**TITLE: AIR CONDITIONING - REMOVE INTERFERENCES BETWEEN ACSC  
AND LGCIU SIGNALS BY SHIELDING OF 47HH AND 57HH WIRE**

MODIFICATION No.: 153571K15409

This page transmits Revision No.01 of Service Bulletin No.A320-21-1208

Figure A-FBDAC - Sheet 03  
Modification of the Plate in the Cargo Compartment.

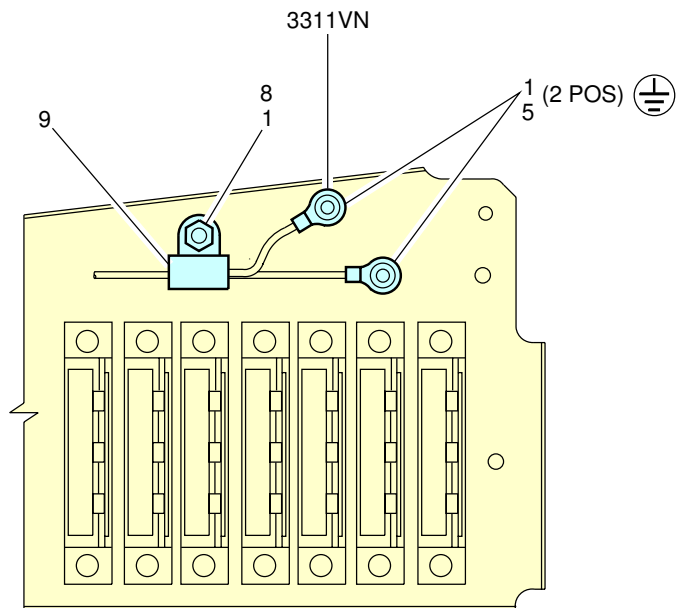
(c) Install the grounding point 3311VN with (Refer to [Fig. A-FBDAC Sheet 03](#)):

(d) Attach the shielding wires with (Refer to [Fig. A-FBDAC Sheet 03](#)):

Figure A-FWAAA - Sheet 01  
 Modification of the wiring between the Avionics and the Cargo Compartment (LH Side).

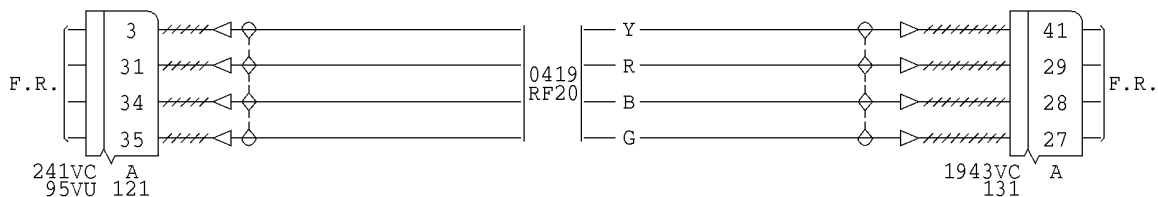
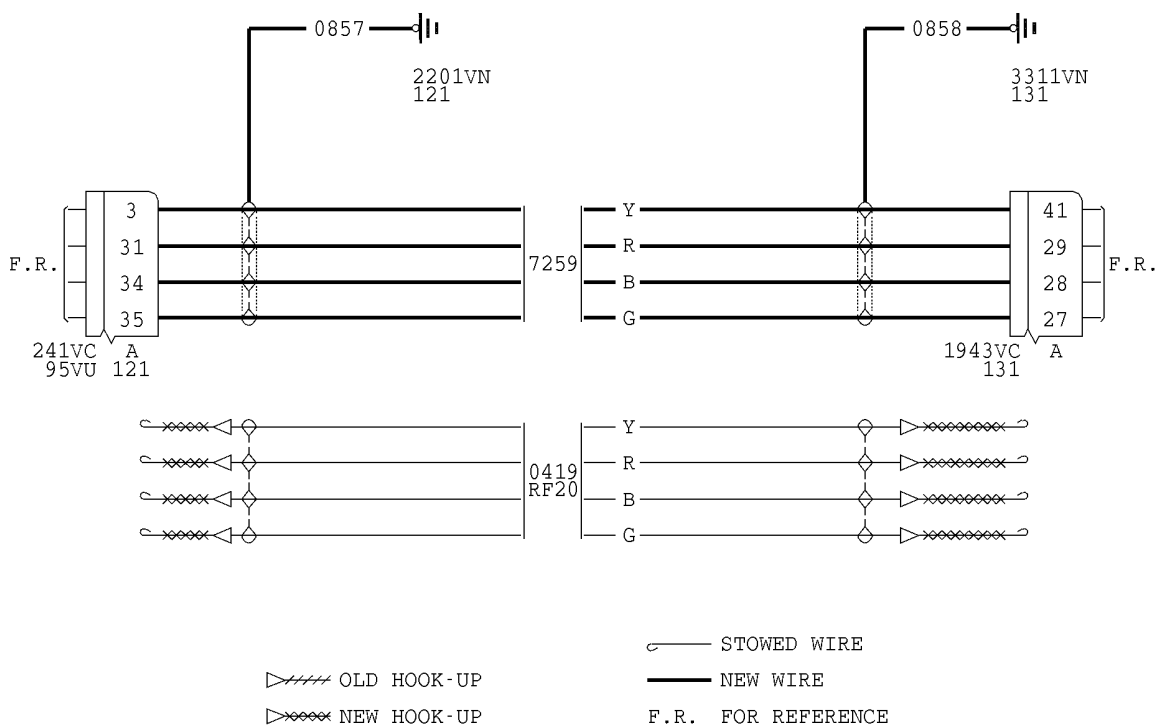
- (a) Modify the connection of the wires as shown in the wiring diagrams [Fig. A-FWAAA Sheet 01](#) and [Fig. A-FWBAA Sheet 01](#), and as described in the hook-up chart lines:

- (b) Install the wires as shown in the wiring diagrams [Fig. A-FWAAA Sheet 01](#) and [Fig. A-FWBAA Sheet 01](#), and as described in the hook-up chart lines:

Figure A-FWBAA - Sheet 01  
 Modification of the wiring between the Avionics and the Cargo Compartment (RH Side).

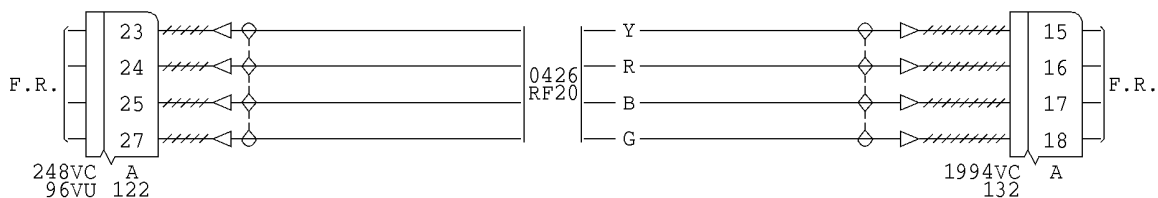
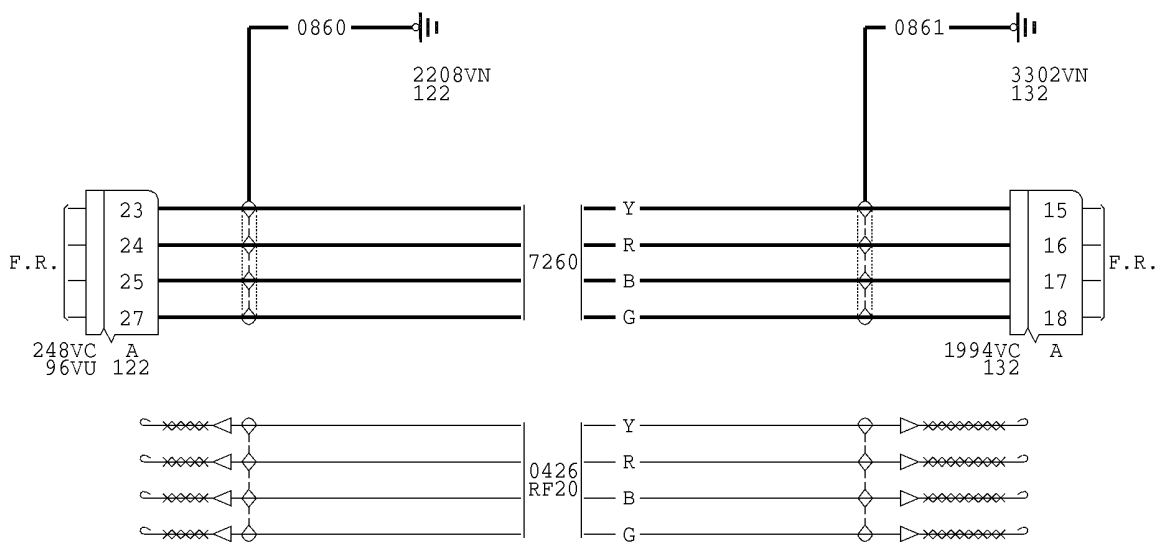
- (a) Modify the connection of the wires as shown in the wiring diagrams [Fig. A-FWAAA Sheet 01](#) and [Fig. A-FWBAA Sheet 01](#), and as described in the hook-up chart lines:

- (b) Install the wires as shown in the wiring diagrams [Fig. A-FWAAA Sheet 01](#) and [Fig. A-FWBAA Sheet 01](#), and as described in the hook-up chart lines:
